September 12, 2013

**Subject: Bingham Wind Project
Response to Additional Stormwater Review Comments
L-25973-24-A-N/L-25973-B-N, Bingham Wind Project, Bingham et al.**

We are pleased to provide the accompanying responses to Art McGlauffin's additional stormwater review comments dated August 28, 2013 for the proposed Bingham Wind Project. For ease of reference, we have repeated the comments below (*italics*) followed by our response (**bold**).

SHEET
C-N1.10

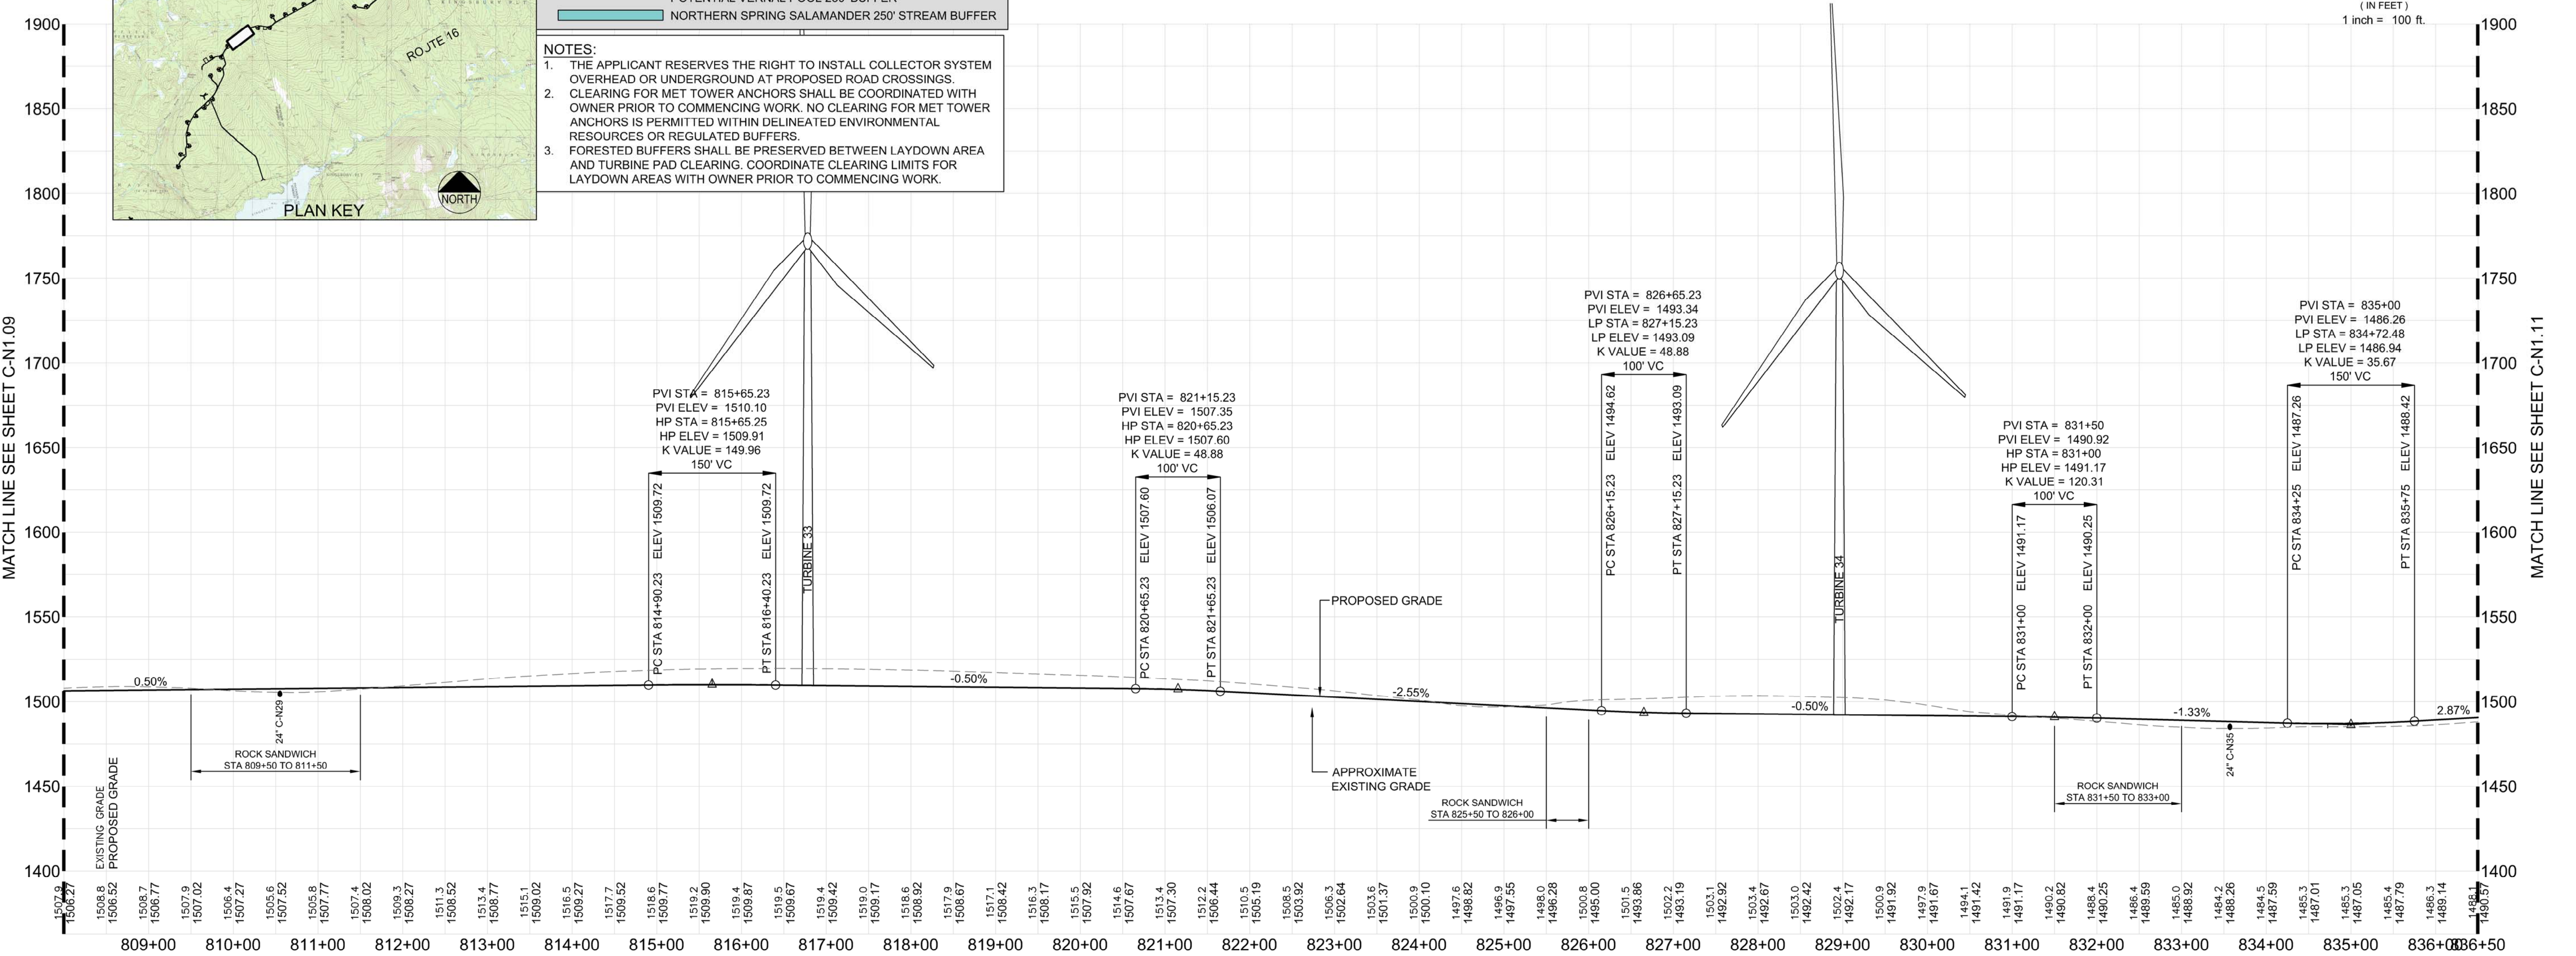
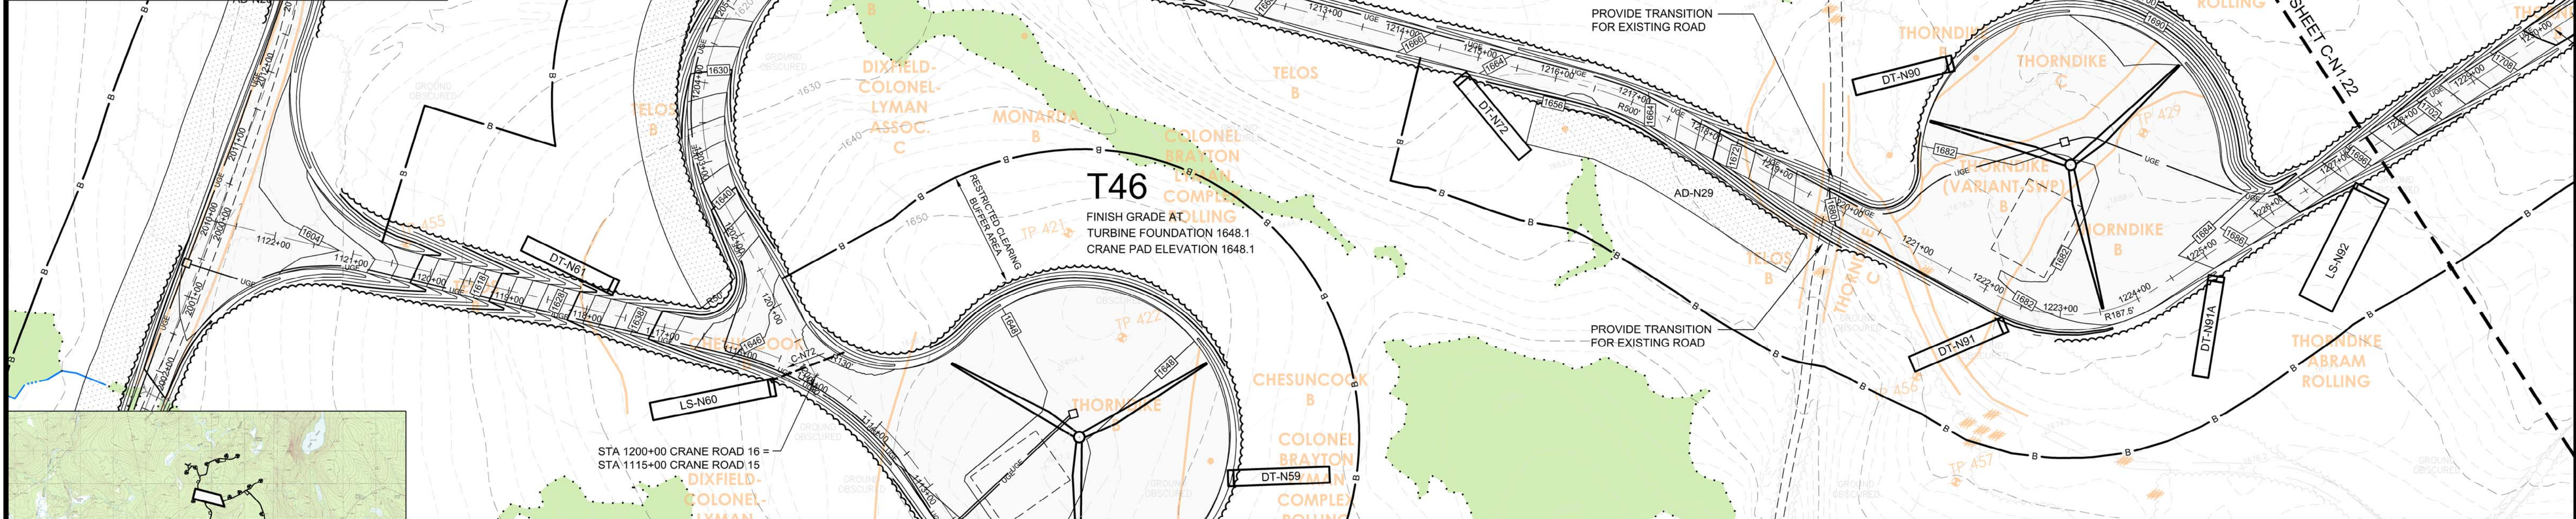
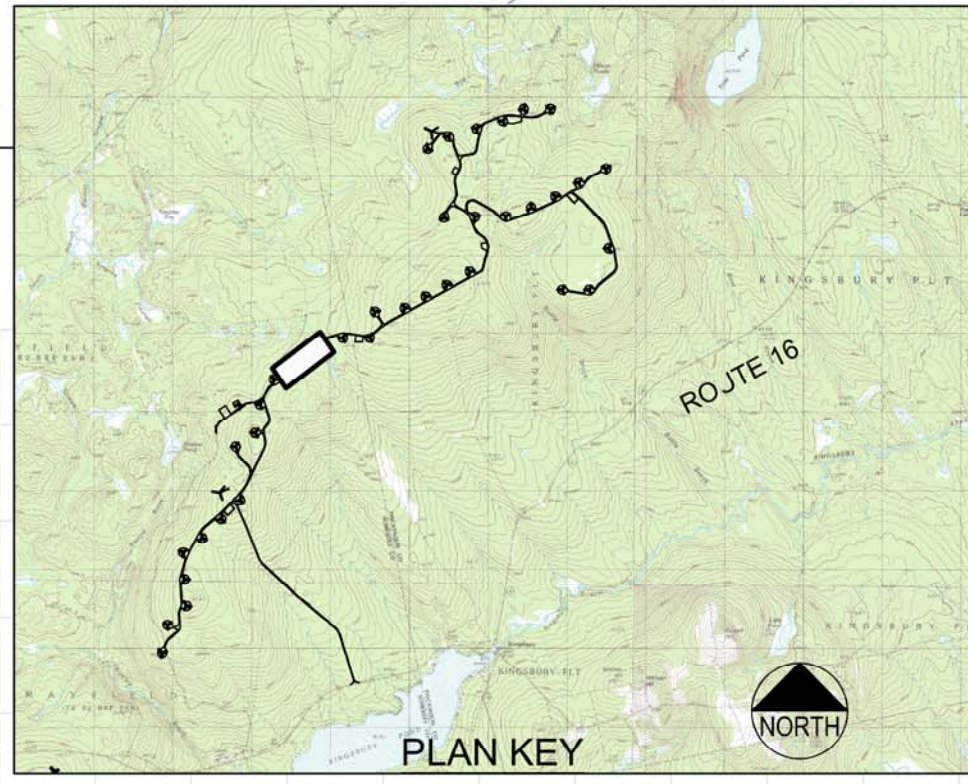
61. *The North Crane Road 11 ditch length draining to DT-N27 exceeds 190 feet (the maximum I am willing to allow for ditch turnout buffers with silt-loam soil). An additional turnout will be needed along this road section or the buffer redesigned to be a buffer with stone berm level lip spreader (see plan sheet C-N1.10).*

65. *AD-N14A needs to be shown on plan sheet C-N1.10. This roadside buffer treats runoff from North Crane Road 11 from station 832+00 to 833+50 in the treatment calculations for the Baker Flowage.*

DT-N27 has been changed to a stone berm level spreader. Treatment calculations have been revised; this treatment along North Crane Road 11 is now labeled as LS-N27. See attached Sheet C-N1.10.

AD-N14A is shown on the attached plan sheet C-N1.10.

SHEET **C-N1.21**

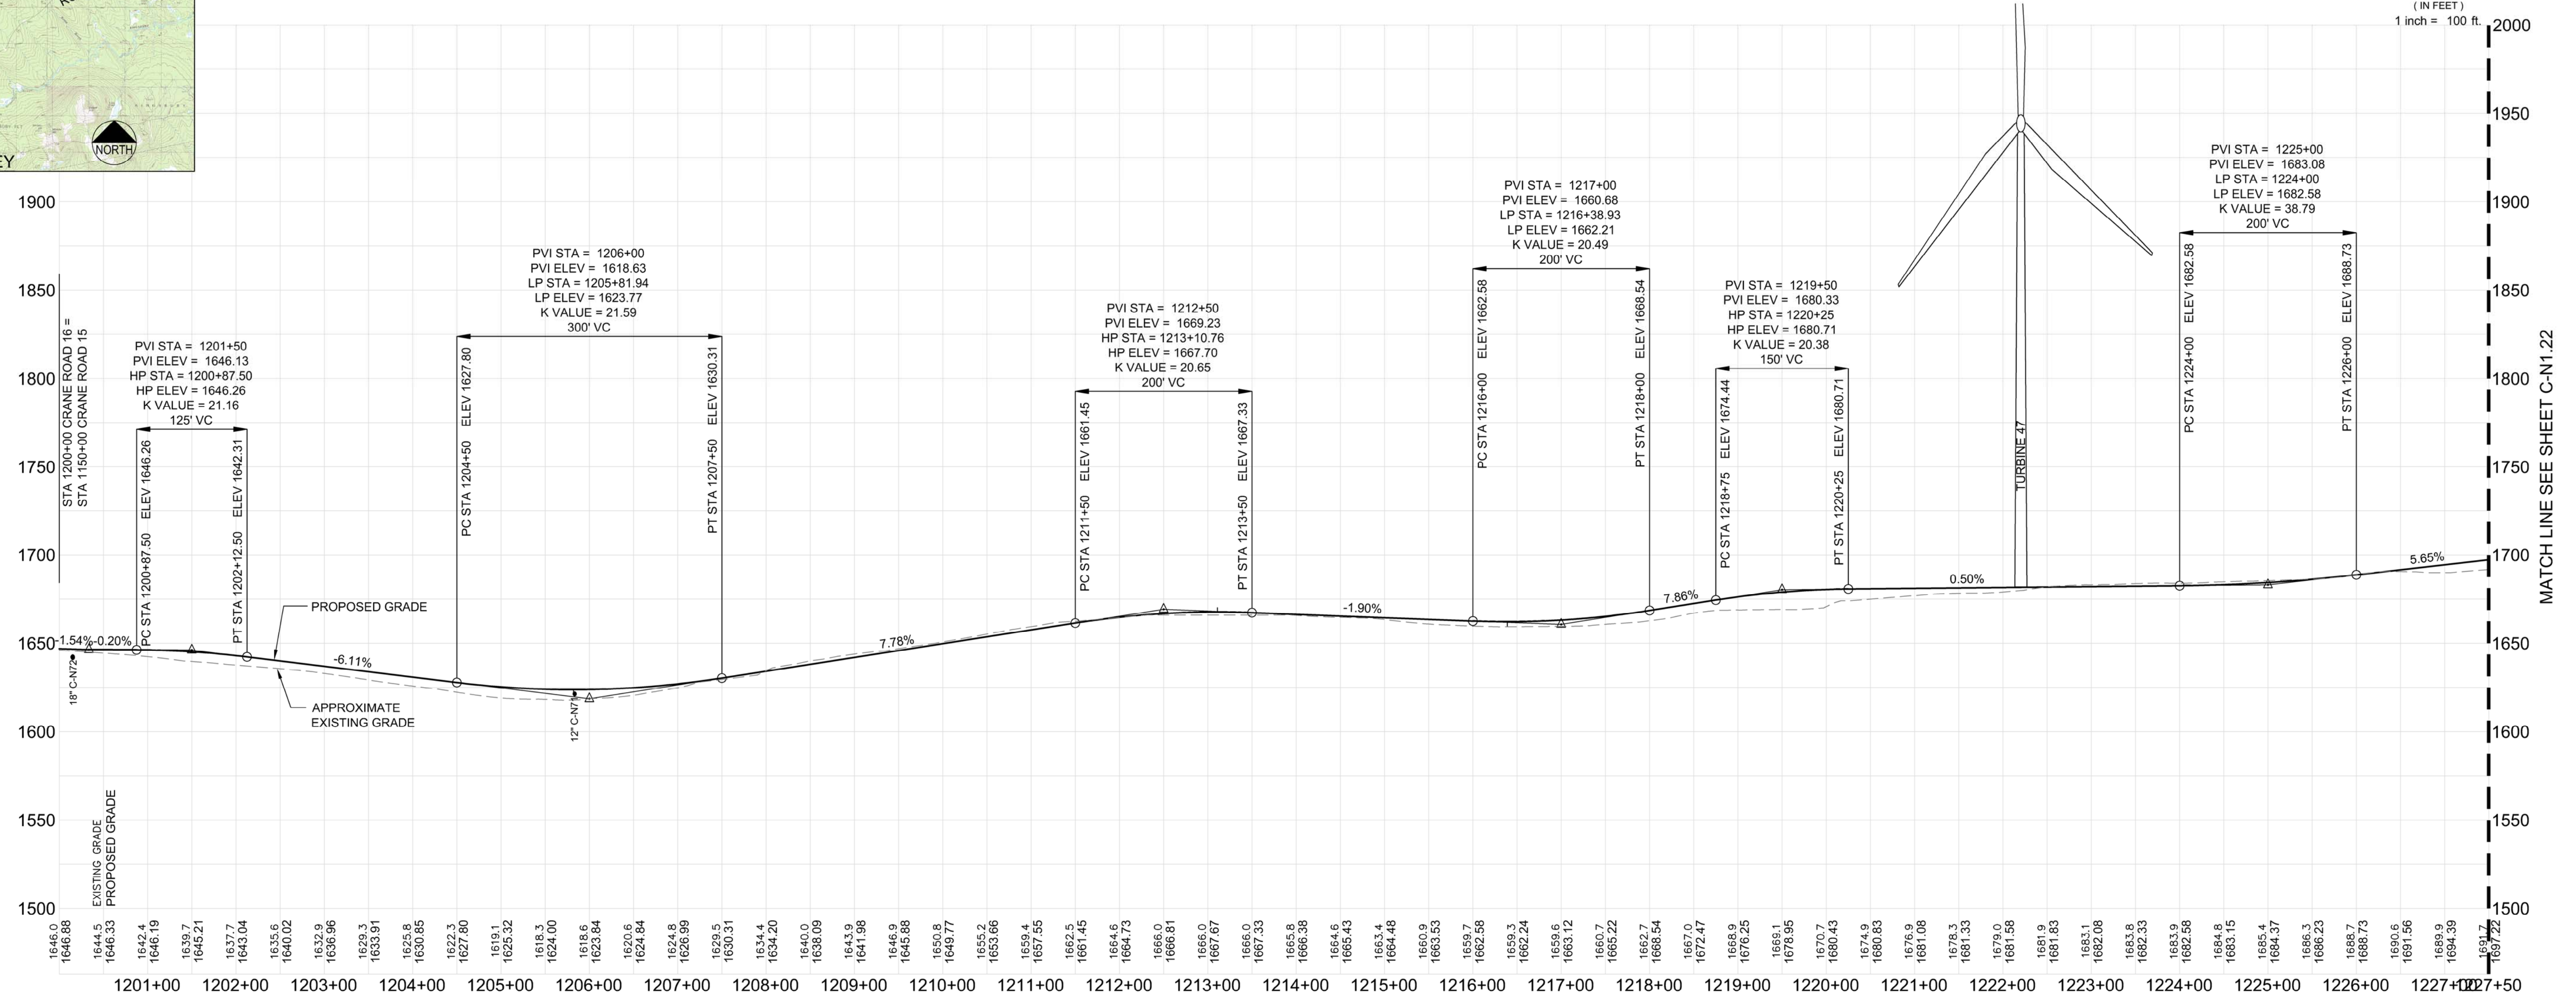
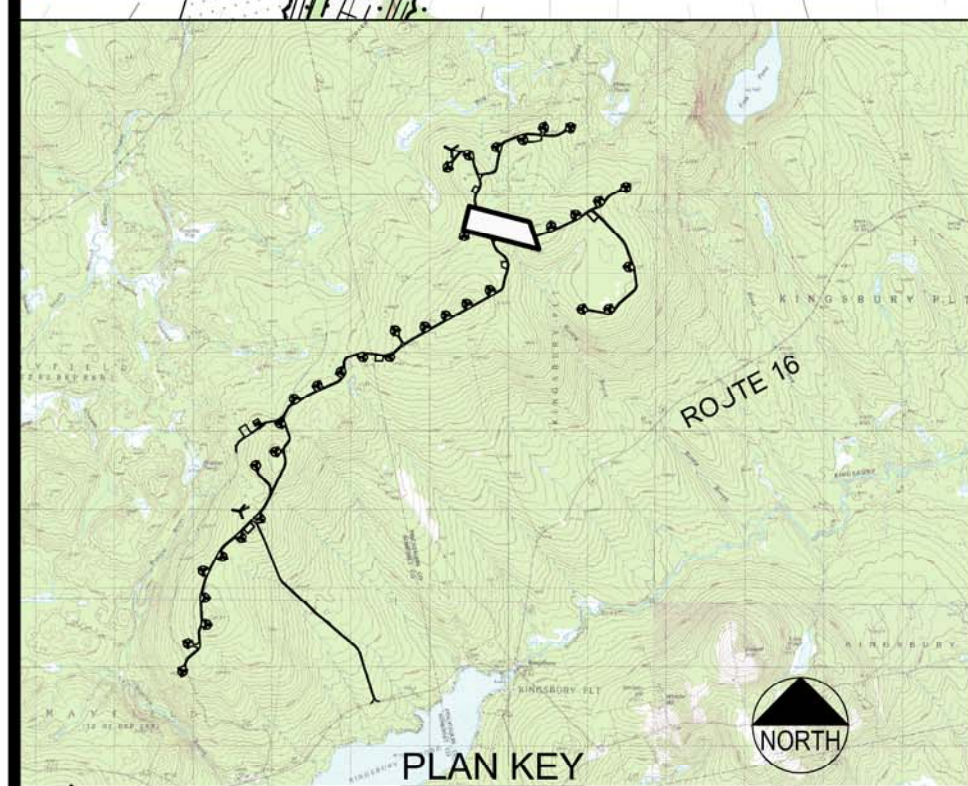
70. *DT-N70 and DT-N70A don't appear to have ditches draining to them (see plan sheet C-N1.21). It appears that DT-N70 and DT-N70A could be replaced by extending roadside buffer AD-N30. This would allow treatment of runoff from North Crane Road 16 from station 1201+00 to station 1202+50 (but not from station 1200+00 to station 1201+00) in AD-N30.*

DT-N70 and DT-N70A have been removed and replaced with AD-N30. Treatment calculations have been revised and are attached.
